Access Compliance Report

Public Rights-of-Way

(Curb Ramps)

Intersection ID: 11615	Main Street: E_18TH_ST	Cross Street: N_ALEXANDER_ST	Location: S
ADA ID: D5FF96F0E036	Ramp Type: Perp	Initial Pass/Fail: Fail	Overall Compliance: No
		Severity Score: 12.5

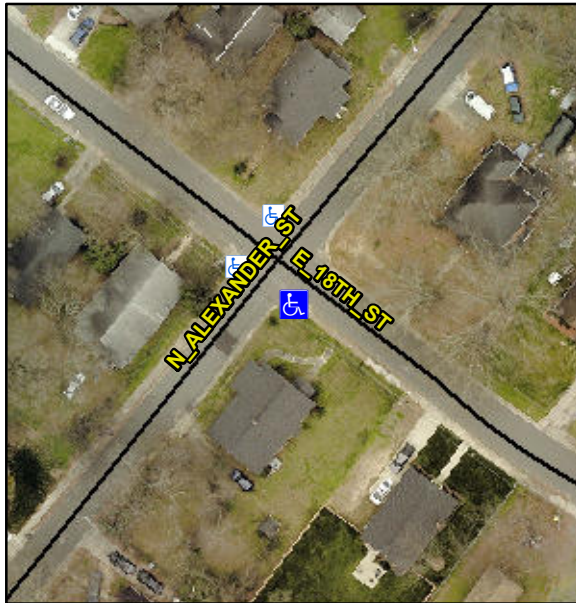
Not Found, R304.2.2

Compliance	Description	Data	Compliance	Description	Data
N/A	Ramp Length (in)	33.0	No	Ramp Slope (%)	11.4
Yes	Ramp Width (in)	50.0	Yes	Ramp XSlope (%)	1.3
N/A	Flare Type LT	N/A	N/A	Flare Type RT	N/A
N/A	Flare Slope LT (%)	N/A	N/A	Flare Slope RT (%)	N/A
N/A	Flare Traversable LT?	N/A	N/A	Flare Traversable RT?	N/A
N/A	Landing Length (in)	N/A	N/A	DWS Provided?	N/A
N/A	Landing Width (in)	N/A	N/A	DWS Contrast?	N/A
N/A	Landing Slope (%)	N/A	N/A	DWS Length (in)	N/A
N/A	Landing X Slope (%)	N/A	N/A	DWS Full Width?	N/A
N/A	Landing Curb? (Y/N)	N/A	N/A	DWS Offset (in)	N/A
N/A	Shared Landing?	N/A			
N/A	Gutter Ponding?	N/A	N/A	Gutter Slope (%)	N/A
N/A	Gutter Lip Ht (in)	N/A	N/A	Gutter X Slope (%)	N/A
N/A	Painted X Walk1?	No	N/A	Painted X Walk2?	N/A
	X Walk 1 Direction	To NW		X Walk 2 Direction	N/A
N/A	X Walk 1 Width (in)	N/A	N/A	X Walk 2 Width (in)	N/A
	X Walk 1 Slope (%)	1.9		X Walk 2 Slope (%)	N/A
	X Walk 1 X Slope (%)	1.6		X Walk 2 X Slope (%)	N/A

Remove & Replace Entire Ramp.
